Subject: Signature HealthCare Expansion  
Responses to Community Design Commission Review Comments

**SIGNATURE HEALTHCARE FACILITY EXPANSION**  
 CHAPEL HILL, NORTH CAROLINA  
**ZONING COMPLIANCE PERMIT DRAWINGS**

14 BED, 9,600 SQ. FT. SHORT TERM REHAB ADDITION TO EXIST. SKILLED NURSING FACILITY FOR SIGNATURE HEALTHCARE OF CHAPEL HILL  
 1602 E. FRANKLIN STREET CHAPEL HILL, NC 27514

Dwn By: CH  
 Chkd By: TW  
 Scale: 1/16"=1'-0"  
 Date:  
 Drawing No. **A-3.1**

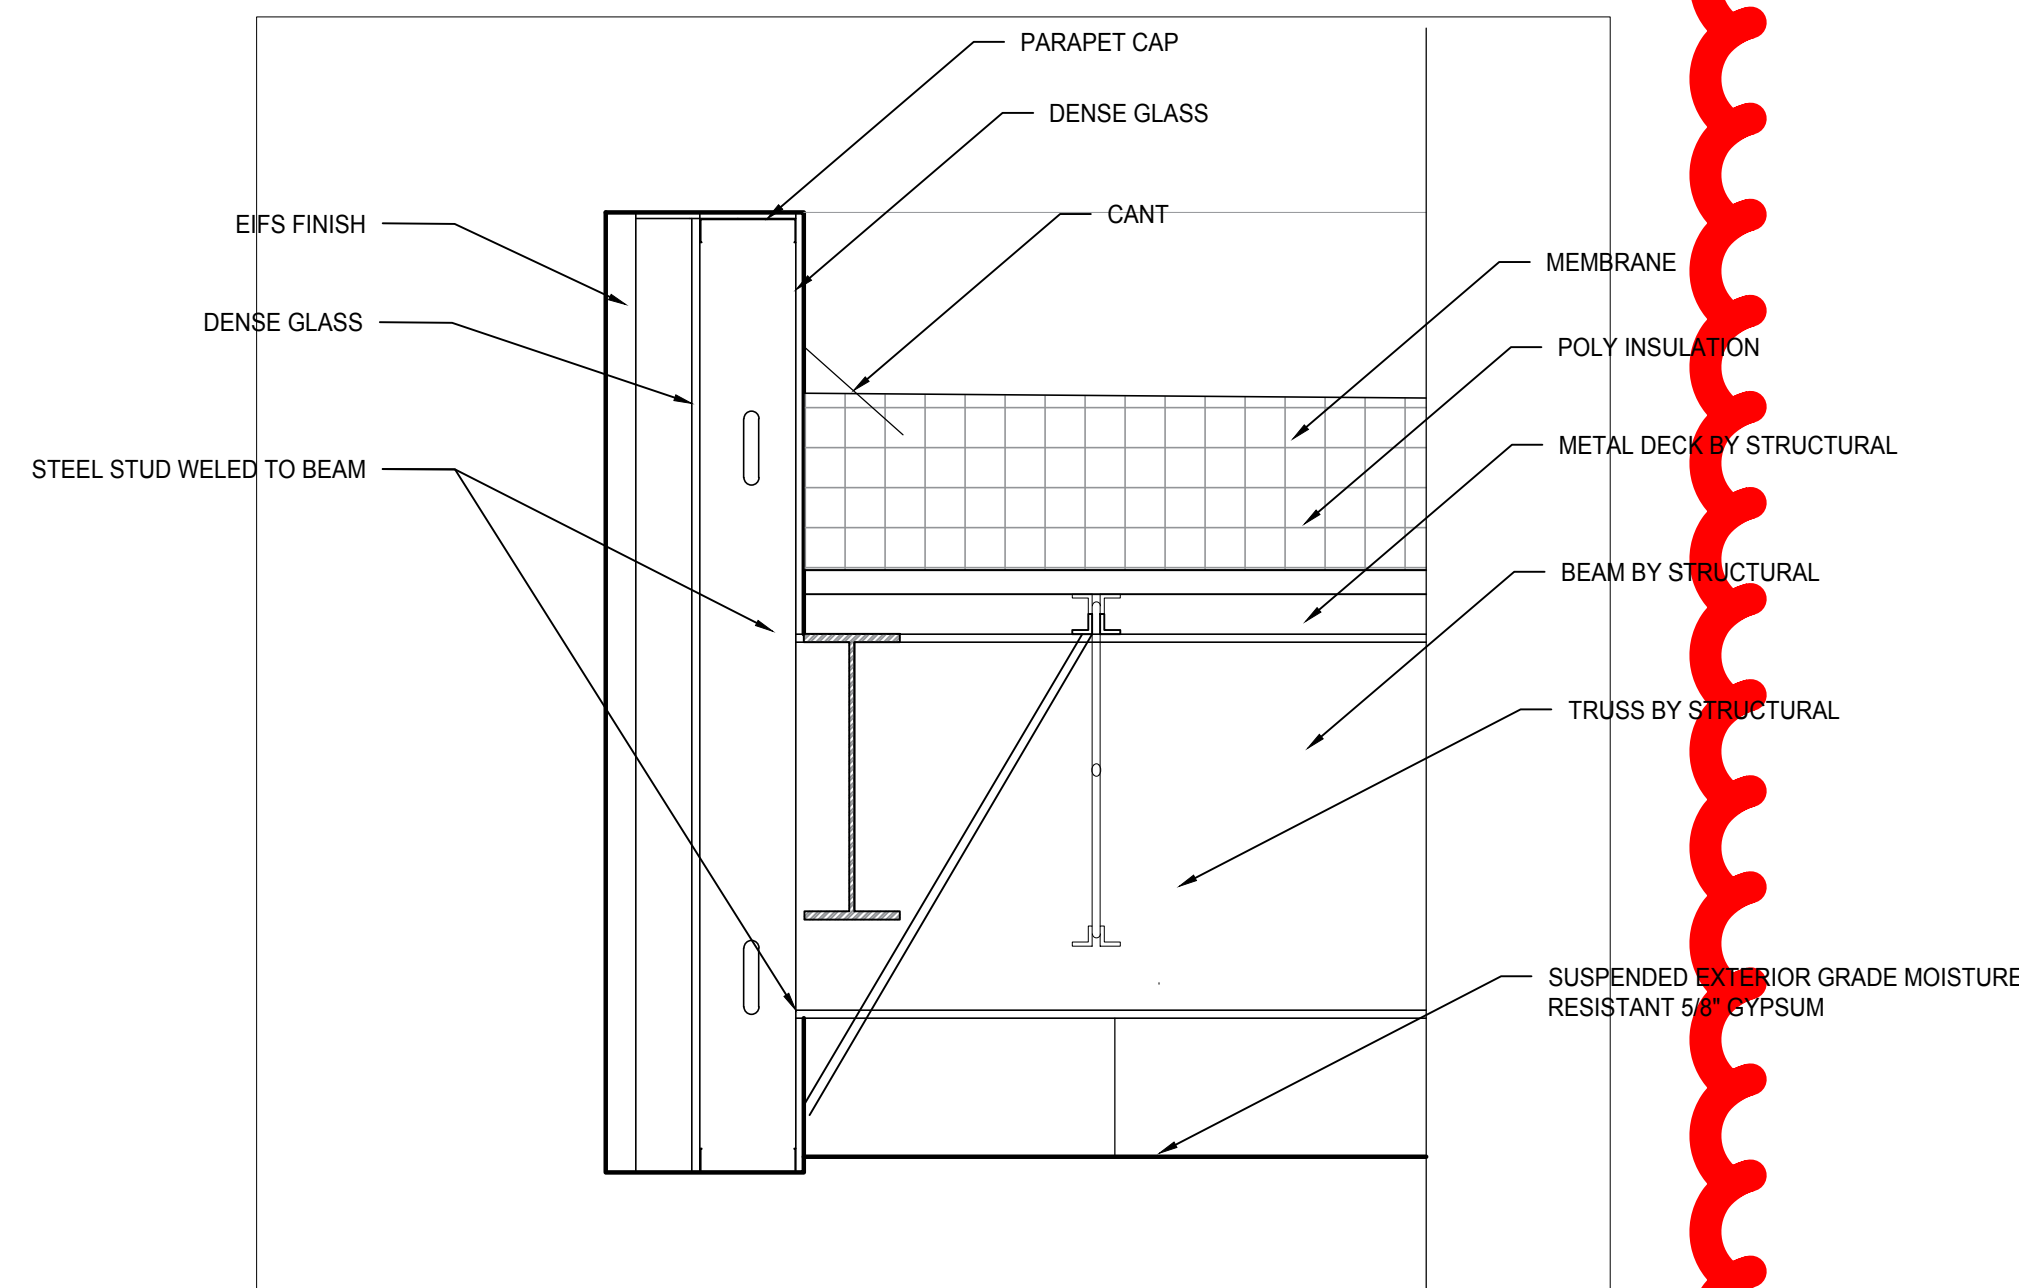
Provide details to show how mechanical equipment (if any) to be located on new roof will be screened from views.

*We have included architectural plan sheets A-3.1 Roof Plan and A-3.7 with HVAC screen details showing that the mechanical equipment on the roof will be screened from views.*

*Drainable EIFS Assembly - TO BE USED FOR THE SHC CHAPEL HILL RENOVATION*

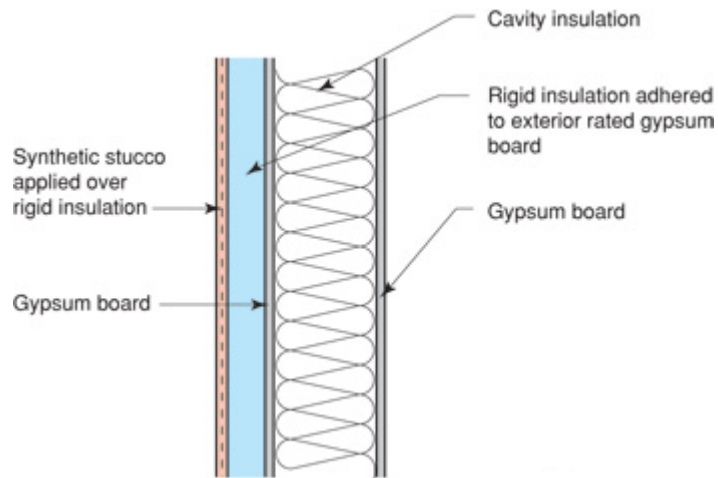
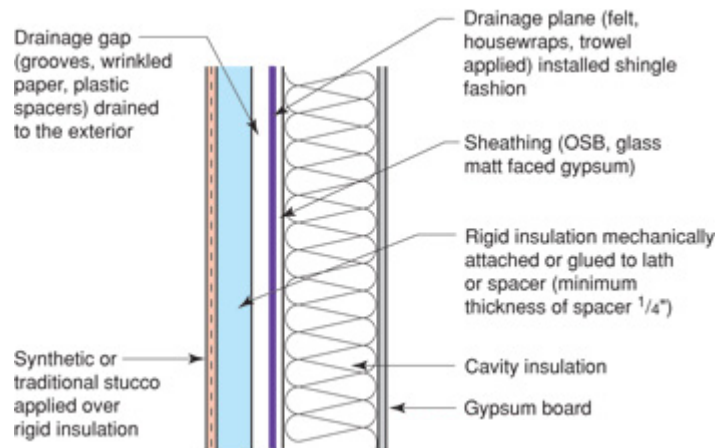
- Concern over durability of EIFS, down low in particular where damage may occur. Consider alternate material; suggestions include metallic siding or a composite such as Alucobond: <https://www.alucobondusa.com/> (see attached email from Chris Brendt)

*The Signature HealthCare Board has considered this recommendation and although EIFS siding has shown durability issues in the past, the technology has improved in recent years and a durable product will be used on the exterior of the new entrance feature. The new EIFS drainable system will be installed to prevent moisture issues (an example of the drainable system is included with this package). To prevent/minimize damage from contact, a heavy duty (min. 20 oz.) mesh will be used for EIFS surfaces at grade and up to 8' above grade.*
